Status Letter #1 for a Draft Plan of Subdivision – Easton
Part of Lots 16, Concession 6 in the Geographic Township of Lanark, Township of Lanark Highlands, County of Lanark
County File No. 09-T-25004

Lanark County Planning Preliminary Comments
Draft Plan of Subdivision - Easton
Part of Lots 16, Concession 6 in the Geographic Township of Lanark, Township of Lanark Highlands, County of Lanark
County File No. 09-T-25004

To:	Diane Reid, Environmental Planner
From:	Jane Cho, Water Resources Engineering Intern Alana Perez, Water Resources Engineer Rikke Brown, Water Resources Engineer
RE:	SWM Engineering Review of the Draft Plan of Subdivision Application for Middleville Subdivision, Township of Lanark Highlands, Lanark County
MVCA File No.:	PLHSB-2
Munic. Ref. ID.:	09-T-25004
Date:	February 13, 2026

Figure 1: Contributing Area of the Tributary at Crossing of Wolf Grove Road (OWIT)

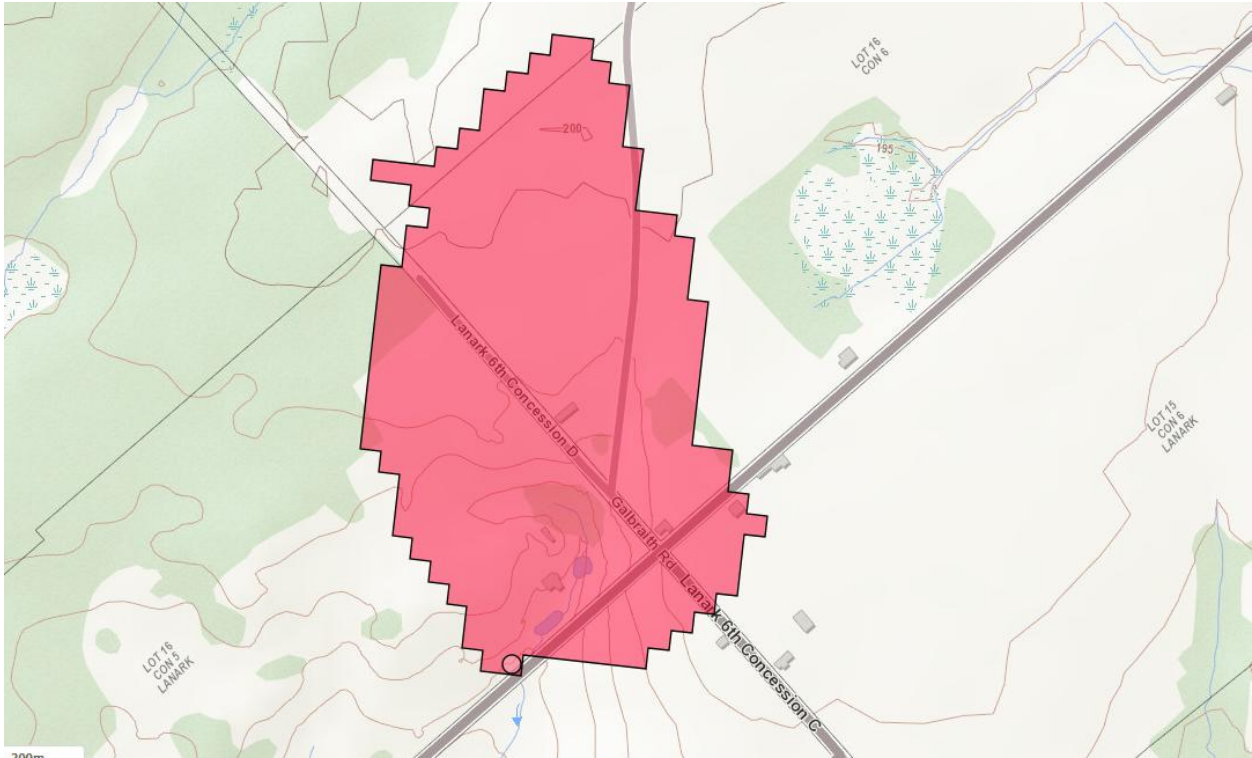
The area contributing to the tributary is roughly estimated to be less than 35ha (see Figure 1). This represents a very small contributing area and would be insufficient to feed a continuously flowing watercourse unless supported by a substantial groundwater source. The landowner notes the presence of a groundwater source to the tributary. Not much is known about the aquifer supporting this spring.

As such, it is not clear why the treatment would have been placed online since it would introduce contaminated water into the watercourse – the very feature to be protected. Stormwater quality treatment should not be performed online. It is clear that the design and construction of the works were completed with the knowledge of the drainage regime in place at that time and is still in place.
